RE: DRAFT Integrated Resource Plan 2023

Annexure A – Industry Comments

Table 1: IRP2023 Industry Inputs and Comments

Figure 3: Overview of existing fleet EAF assumptions (%)

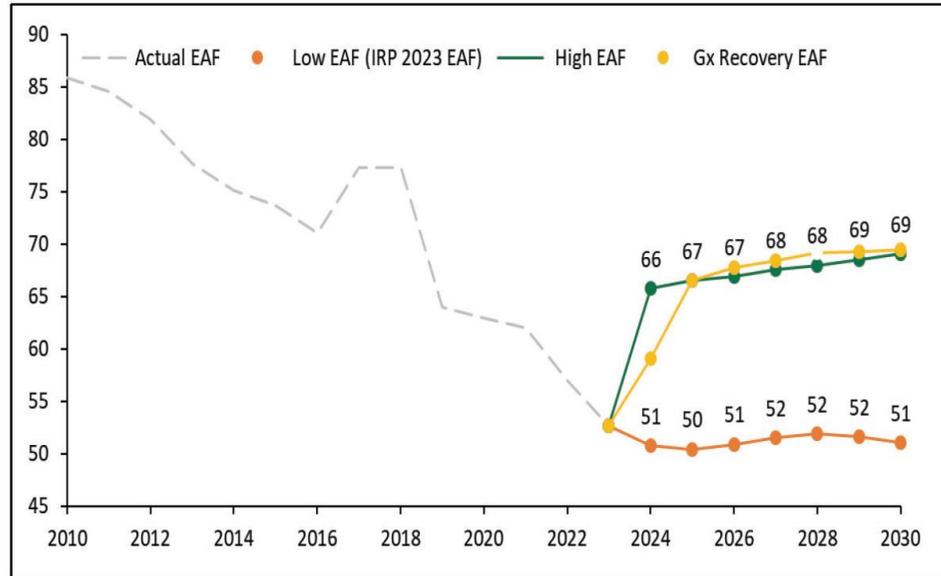
Given the VGBE report, are existing coal fired power plants able to meet the ramp rates?
